ENGINEERING EVIDENCE STATEMENT

SUNBURY SOUTH PSP &
35-60 FOX HOLLOW DRIVE, SUNBURY

PREPARED BY ANDREW MATHESON FOR
ASIA-PACIFIC PROPERTY GROUP PTY LTD
AUGUST 2017

Cut/Fill Diagram – Taylors Revised Alignment (Red = Cut, Green = Fill)

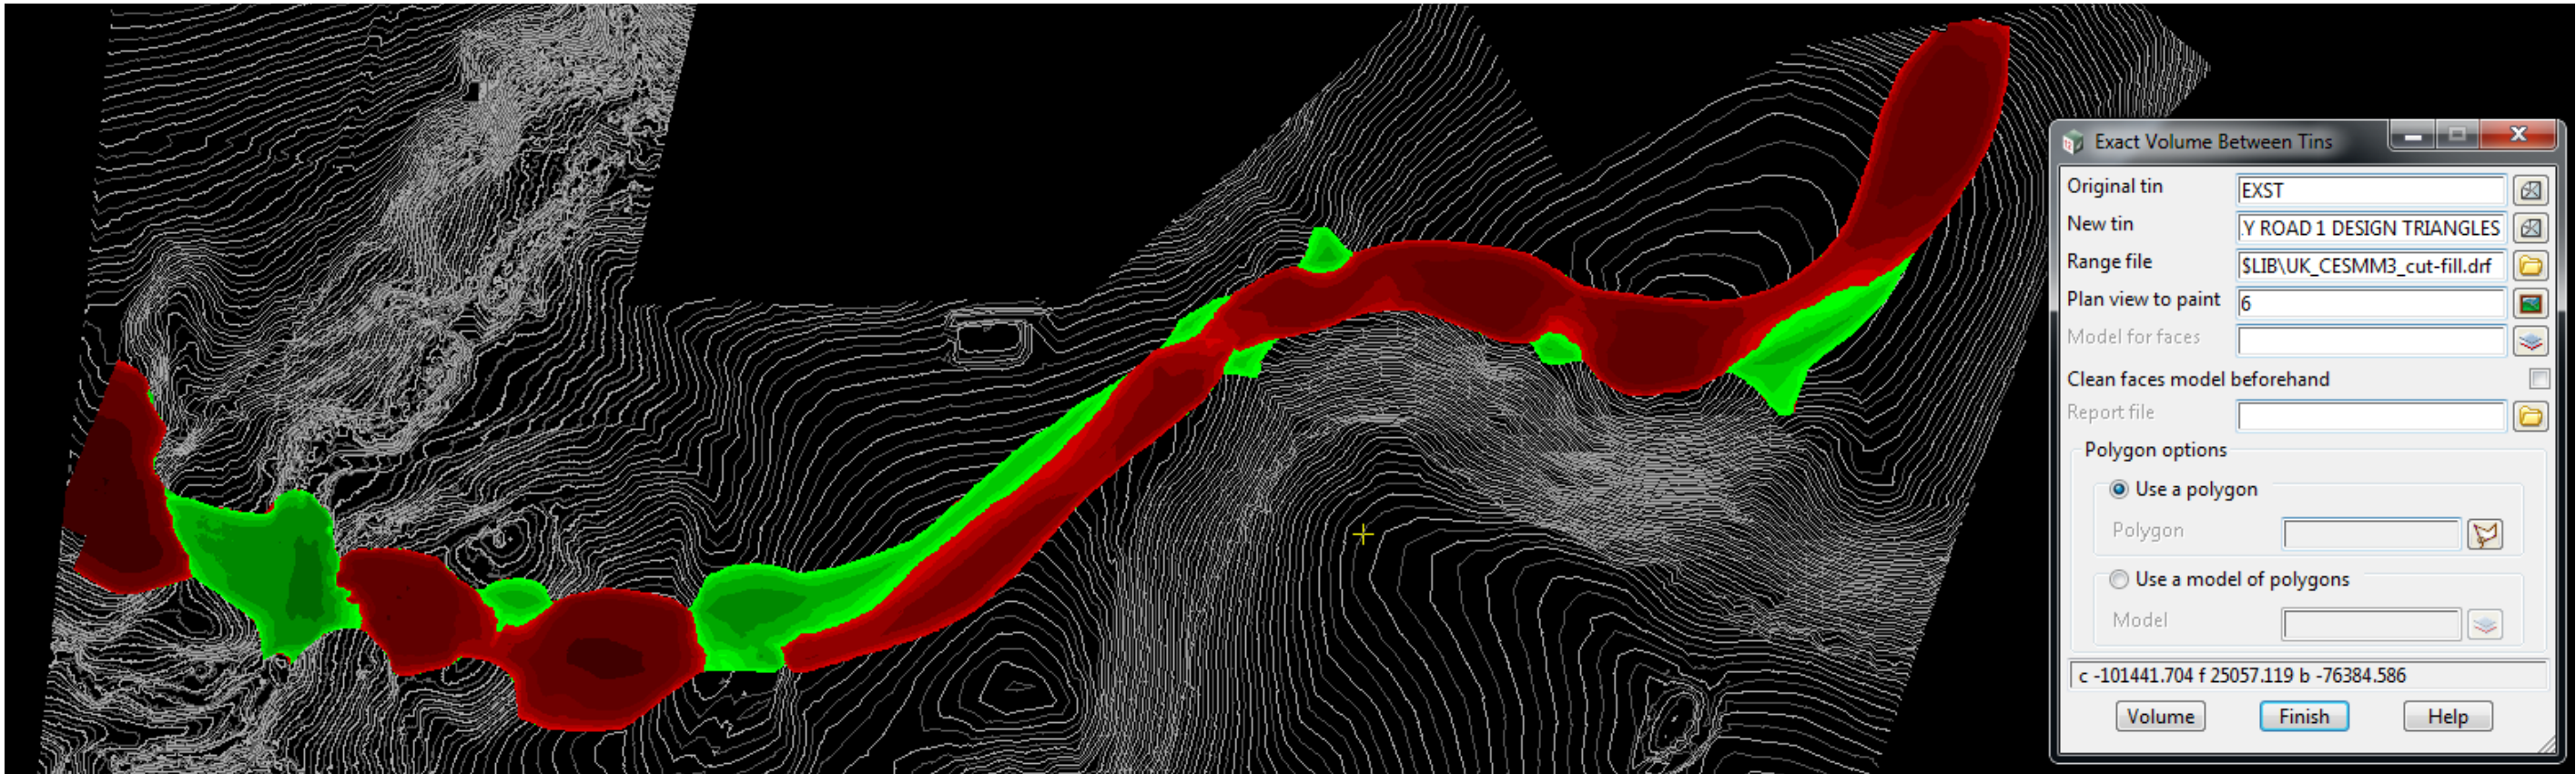
In my opinion, the exhibited PSP alignment for the Connector Boulevard is inefficient. The exhibited alignment pass through land with a significant cross slope. The natural cross-fall along the exhibited alignment averages 1v : 10h or a grade of 10%. Across a 34-metre-wide road reserve, this amounts to 3.4 metres of elevation difference from one side to the other. This difference in elevation must be resolved by either extensive battering or retaining walls. By altering sections of the exhibited alignment to avoid these steeper cross falls, the earthworks component of the Connector Boulevard can be reduced, thus reducing construction and ICP costs. By utilising the existing crest adjacent to the conservation reserve, the slope across the road reserve is greatly reduced. To test these assumptions, I have prepared two designs, the first following the exhibited PSP alignment, and an alternative design utilising the natural terrain as describe above.

- Exhibited PSP Road Length = 1,200 lineal metres;
- Taylors Road Length = 1,260 lineal metres;
- The Taylors Road design having additional 60 lineal metres of length results in more pavement area however is more efficient in earthworks design reducing total excavation volume by approximately 8,500 cubic metres. The total cost of the Taylors alignment, in isolation, is marginally higher than the exhibited PSP alignment, however the location of Taylors' Fox Hollow Drive & Collector Road intersection is further south than exhibited PSP alignment resulting 41 lineal metres less road length in Fox Hollow Drive;

It is my opinion that the revised alignment for the Connector Boulevard is generally in accordance with the exhibited PSP alignment, and achieves the objectives of providing connectivity between Sunbury Road and Vineyard Road while adhering to Austroads design guidelines for urban roads. The revised alignment also has the added benefit of reducing the ICP costs.

- Revise the alignment of the Sunbury Ring Road Southern Link (Connector Boulevard) and corresponding intersection with Fox Hollow Drive to reduce cost to the ICP and earthworks implications onto developable land.
